BLANCHARD LETENDRE
ENGINEERING

Our File Reference No: 23-172

SUBJECT:	2ND REVIEW COMMENTS
PROJECT ADDRESS:	1274 MARYGROVE CIRCLE
PERMIT NUMBER:	FILE # D02-02-23-0016
REPORT TYPE:	ENGINEERING BRIEF

Catchment Map

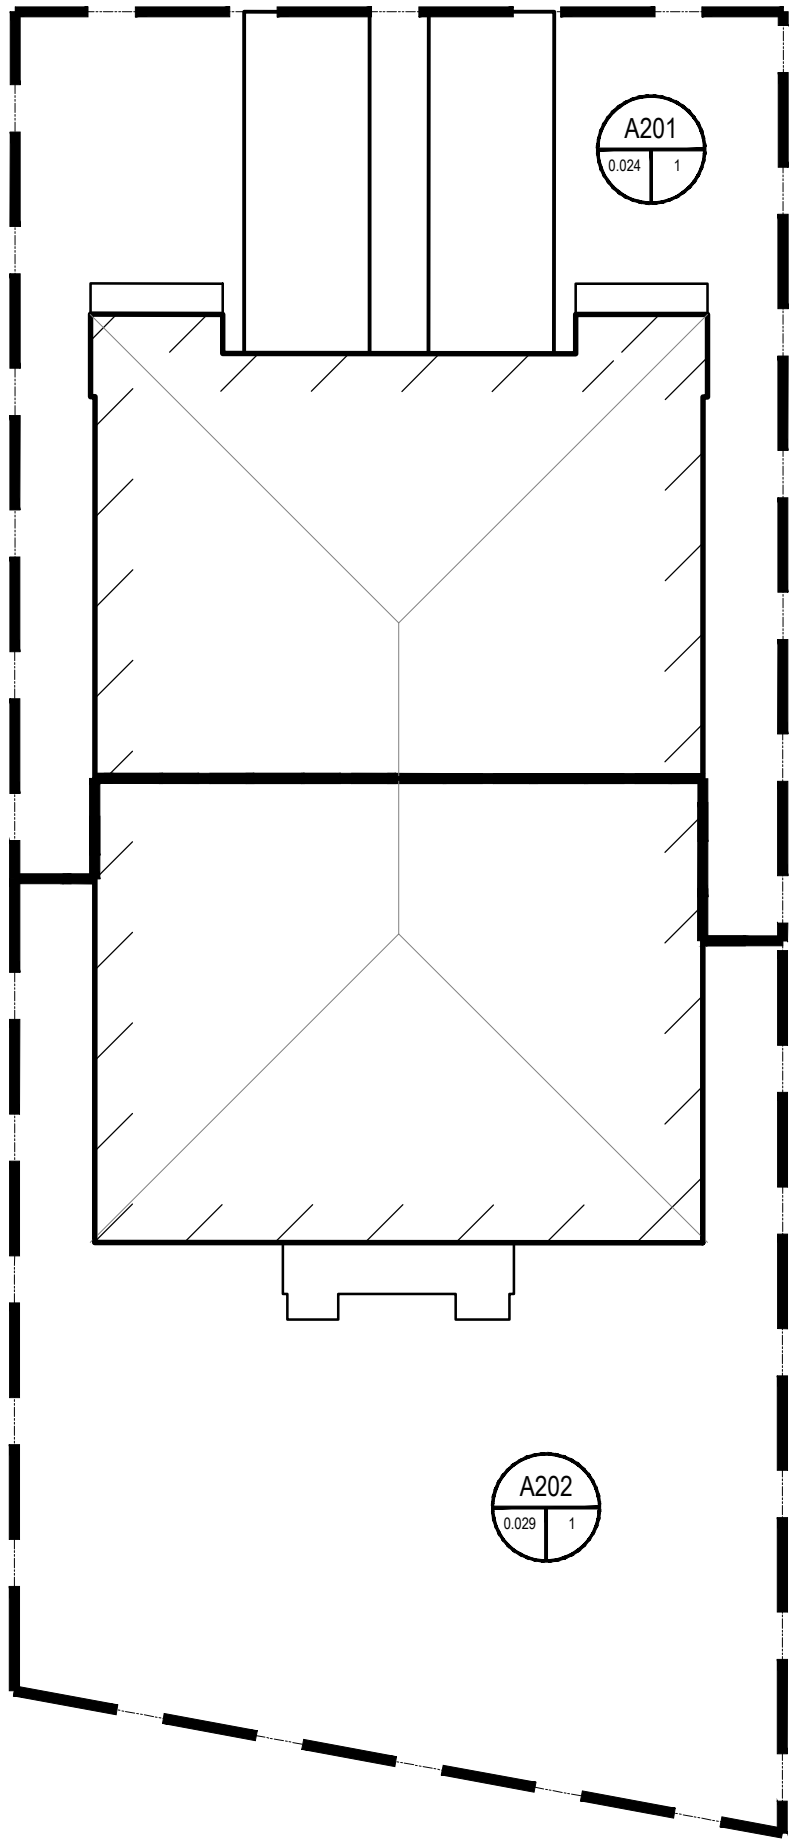
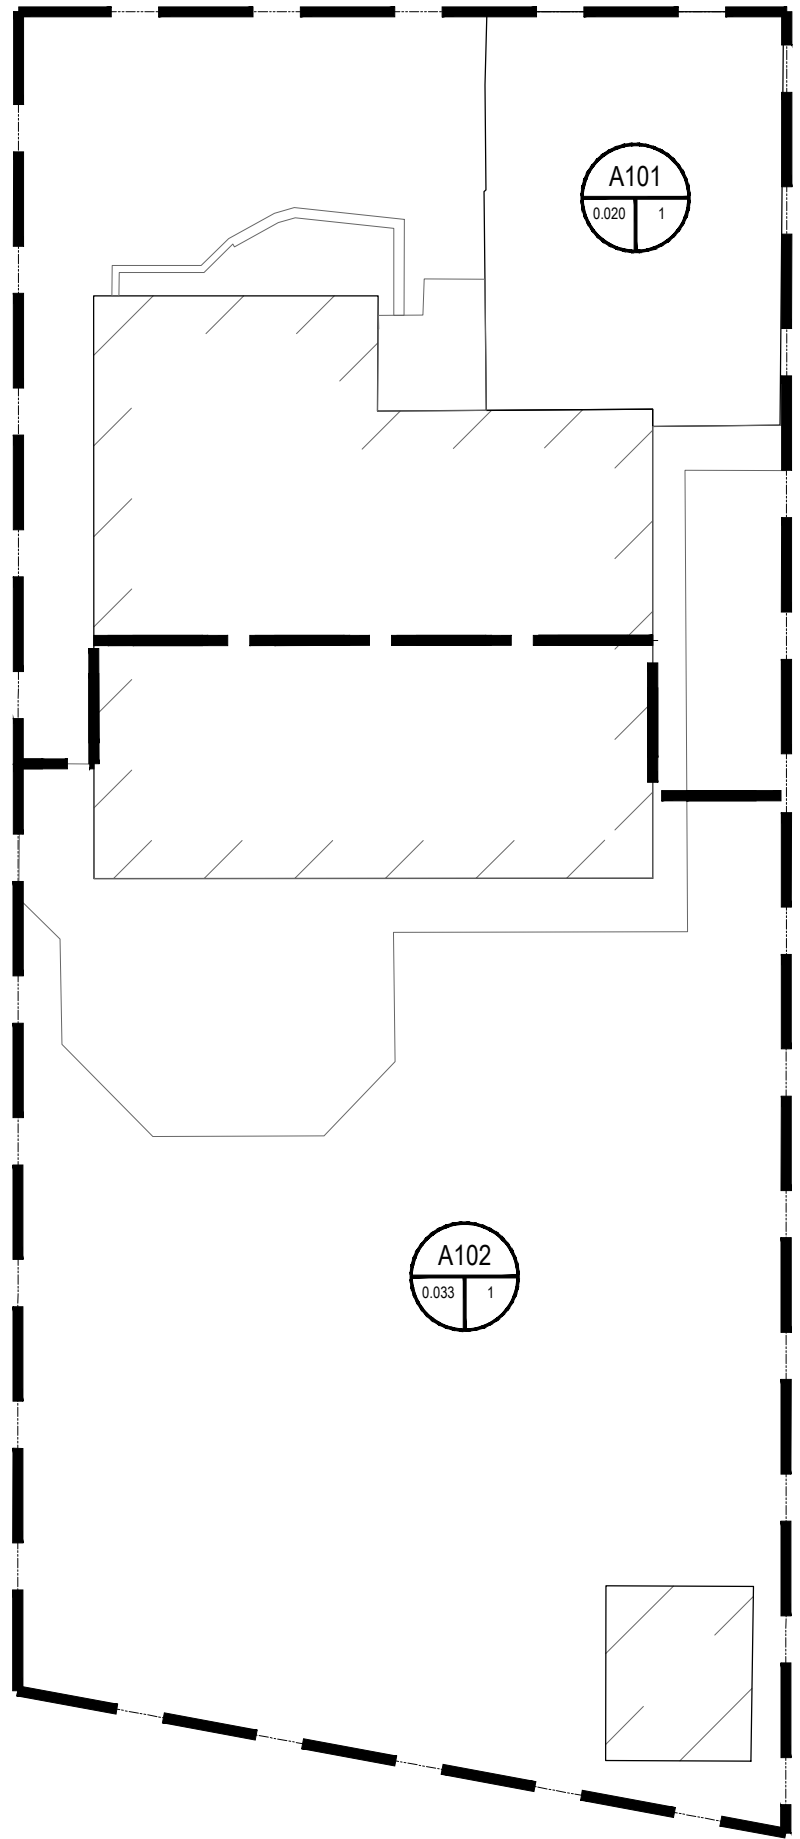
“1.7. The section should discuss the increase in imperviousness. The drainage conveyance methods. How impact to neighbouring properties would be reduced (i.e. roof drains only drain to the street/etc). A drainage sub-catchment plan is helpful.

(City 2023): Outstanding. Excess drainage cannot be directed to neighbouring properties. The stormwater management section must include information on the existing site condition and the changes as a result of the proposal along with mitigation measures. Are there existing drainage issues such as ponding/poor grading etc?”

(LBE Jul 2023): The report has been revised to make general statements on the proposed change in imperviousness, how it is proposed to be graded and drained (by others) A drainage sub-catchment plan is not available, however the grading plan is, from which this information can be inferred.

The proposed development will result in a small net decrease in uncontrolled run-off to the rear property lines as a result of this development, while there will be a small net increase in uncontrolled run-off to the City ROW.

The uncontrolled area to the rear maintains a typical assumed weighted run-off coefficient of C=0.5 for infill development. This is not anticipated to have any impacts to downstream infrastructure.

Both the front yard and rear yard will have higher weighted run-off coefficients in the post development conditions.

No additional mitigation measures are proposed as part of this development at this time.

The extent of existing topography available suggests that the existing overland flow for rear drainage occurs in the overhead utility easement. The flow direction is southward.
